# Access Compliance Report

## Public Rights-of-Way

### (Curb Ramps)

Intersection ID: 18735	Main Street: JESTER_LN	Cross Street: REDCOAT_DR	Location: SE
ADA ID: 46345D1C4525	Ramp Type: PerpDiag	Initial Pass/Fail: Fail	Overall Compliance: No
Severity Score: 13.75			
Codes/Mitigation Info/Possible Solution		Field Measurements/Component Compliance

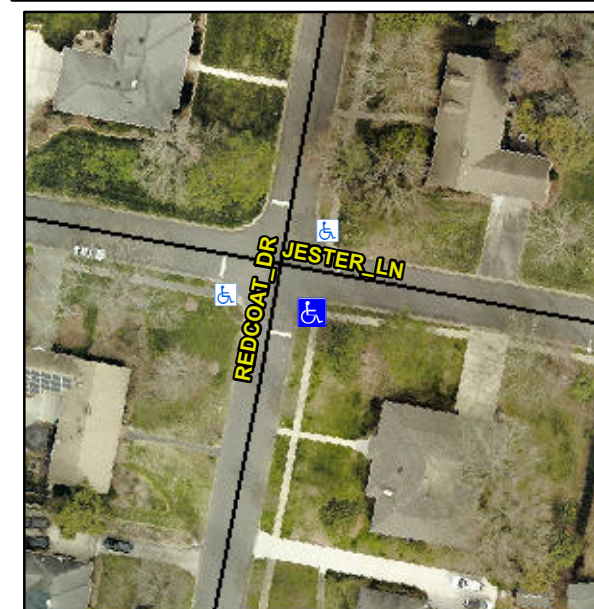
**Not Found, R304.2.2, R304.5.3**

Compliance	Description	Data	Compliance	Description	Data
N/A	Ramp Length (in)	75.0	No	Ramp Slope (%)	10.9
Yes	Ramp Width (in)	48.0	No	Ramp XSlope (%)	2.7
N/A	Flare Type LT	N/A	N/A	Flare Type RT	N/A
N/A	Flare Slope LT (%)	N/A	N/A	Flare Slope RT (%)	N/A
N/A	Flare Traversable LT?	N/A	N/A	Flare Traversable RT?	N/A
N/A	Landing Length (in)	N/A	N/A	DWS Provided?	N/A
N/A	Landing Width (in)	N/A	N/A	DWS Contrast?	N/A
N/A	Landing Slope (%)	N/A	N/A	DWS Length (in)	N/A
N/A	Landing X Slope (%)	N/A	N/A	DWS Full Width?	N/A
N/A	Landing Curb? (Y/N)	N/A	N/A	DWS Offset (in)	N/A
N/A	Shared Landing?	N/A			
N/A	Gutter Ponding?	N/A	N/A	Gutter Slope (%)	N/A
N/A	Gutter Lip Ht (in)	N/A	N/A	Gutter X Slope (%)	N/A
N/A	Painted X Walk1?	No	N/A	Painted X Walk2?	No
	X Walk 1 Direction	To NE		X Walk 2 Direction	To NW
N/A	X Walk 1 Width (in)	N/A	N/A	X Walk 2 Width (in)	N/A
	X Walk 1 Slope (%)	9.3		X Walk 2 Slope (%)	3.8
	X Walk 1 X Slope (%)	2.3		X Walk 2 X Slope (%)	6.0

**Remove & Replace Curb Ramp With Two New Directional Ramps or Equivalent.**
